SAFETY EVALUATION BY THE OFFICE OF NUCLEAR REACTOR REGULATION

GEORGIA POWER COMPANY, ET AL.

VOGTLE ELECTRIC GENERATING PLANT, UNITS 1 AND 2

1.1 Alternate Miniflow System Design

Fig. 1. charging/safety injection system

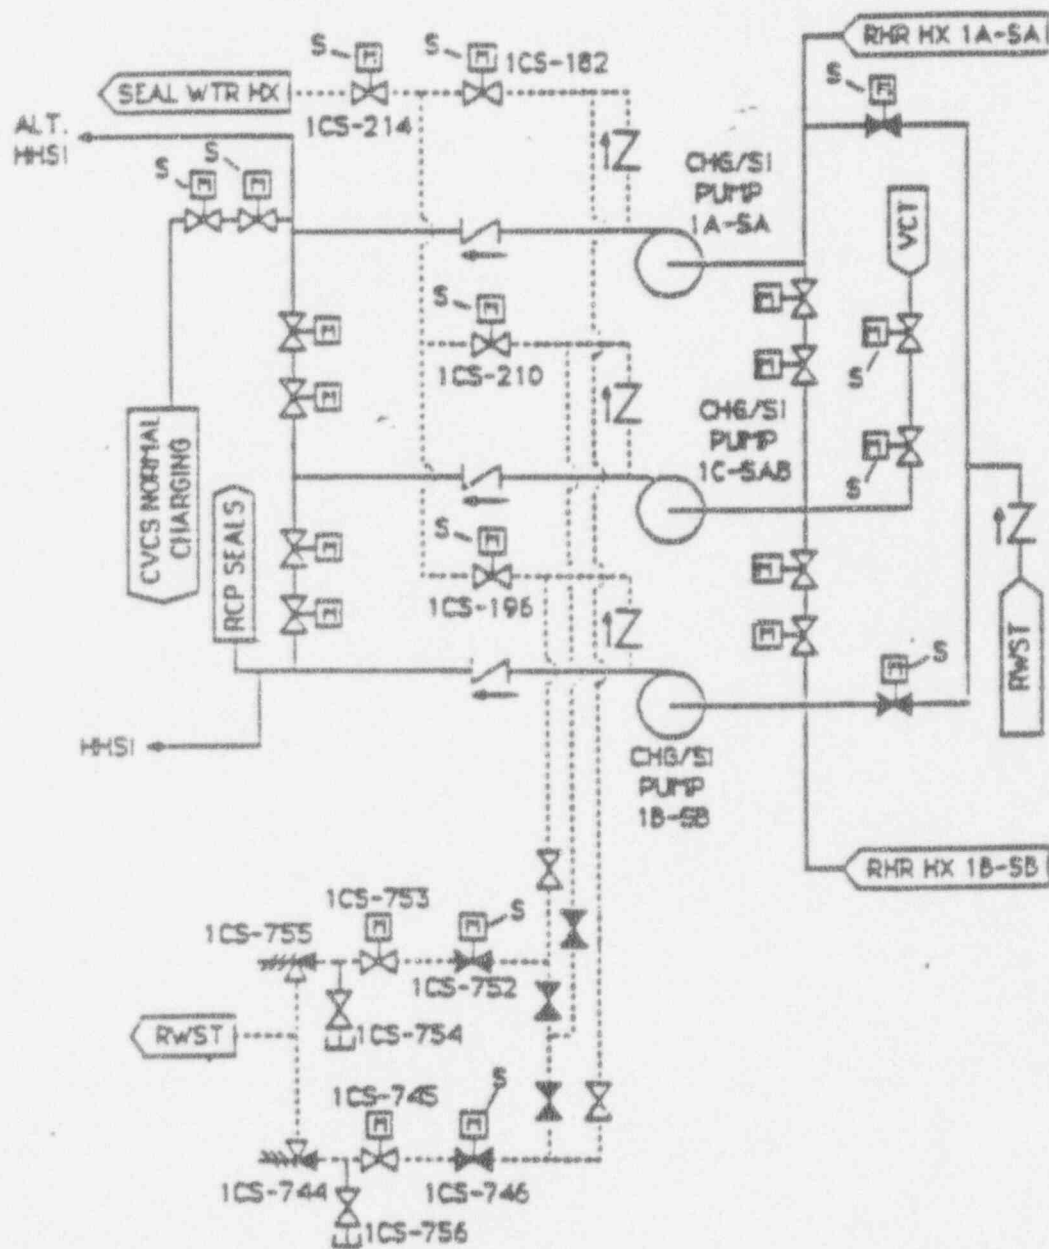
The SHNPP HPI design consists of two charging/SI pumps which perform the charging function during normal plant operation and the HPI function when the ECCS is actuated. A third charging/SI pump is available as a "swing" pump which may be aligned to either of the power trains and either of the AMF paths by manual action. Table 1, attached, and Figure 1 provide design information for the SHNPP HPI and AMF systems.

Tests conducted at SHNPP during a March 1991 refueling outage discovered significant damage to both AMF paths. The damaged equipment and estimated associated diverted flow rates are: 1) first path - failed relief/control valve actuation components, setpoint drift to 1100 psi and flow of 275 gpm, 2) other path - relief/control valve seat leakage, 50 gpm; broken drain line, 500 gpm. An NRC special team inspection report (50-400/92-201, dated August 27, 1992) attributed the damage to waterhammer in the AMF system, and to a design deficiency consisting of excessive piping length (up to 60 ft.) associated with oversized relief/control capacity (275 gpm). A study by the NRC Office of Analysis and Evaluation of Operational Data (AEOD) identified the design as suspect, and associated a conditional probability of core damage of 6.3×10^{-3} with the as-found AMF system.

The licensee for SHNPP modified the AMF at SHNPP to eliminate the relief/control valve. The modified system was reviewed and approved by the NRC. The licensee provided its own probabilistic assessment of the impact of the as-found degraded HPI (including updated input parameters and taking credit for alternate mitigation processes) which identified an estimated conditional probability of core damage of 1.28×10^{-5} . Prior to modifying the AMF, the licensee tested the AMF an additional time with a water-filled system and found damage. The licensee concluded that the damage originally attributed to waterhammer may have been due to other hydraulic forces as well.
